**PLANNING DIVISION REPORT**  
**DEPARTMENT OF PLANNING AND COMMUNITY**  
**AND ECONOMIC DEVELOPMENT**  
**Of April 4, 2007**

**RE: LD. # 05797: Zoning Map Amendment LD. 3249 To Rezone 6506 Old Sauk Road from PUD-GDP to PUD-SIP**

DATE: March 15, 2007  
TO: Plan Commission  
FROM: Larry D. Nelson, P.E., City Engineer  
SUBJECT: 6506 Old Sauk Road Rezoning and PUD (SIP)

TO: Plan Commission  
FROM: David C. Dryer, P.E., City Traffic Engineer and Parking Manager  
SUBJECT: **6506 Old Sauk Road – Rezoning - PUD (GDP) to PUD (SIP) - 9 Unit Condominium Development**

# Proposed Rezoning

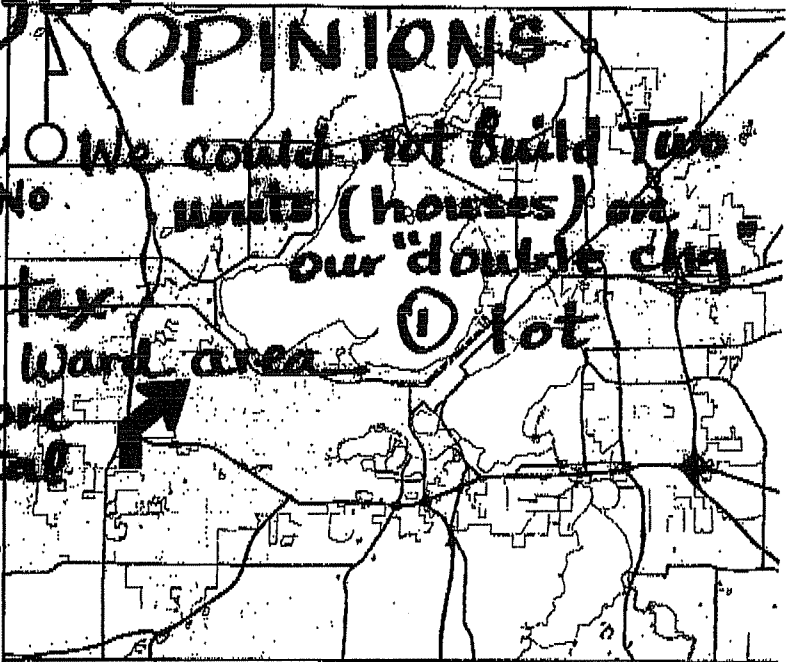
How to make Blg  
on 1.53 acres!

originally SIP-taxed AS!  
false delineation on this "MAP" for express and access - Into our drive

First Houses double city area  
House 2 H Court  
House 1 H Court  
Court is easement to hydrant  
Two lots charge on one House size  
High tax and Dues doubled  
Paid by Association

Consider overbuilt low cost so called "Condos"
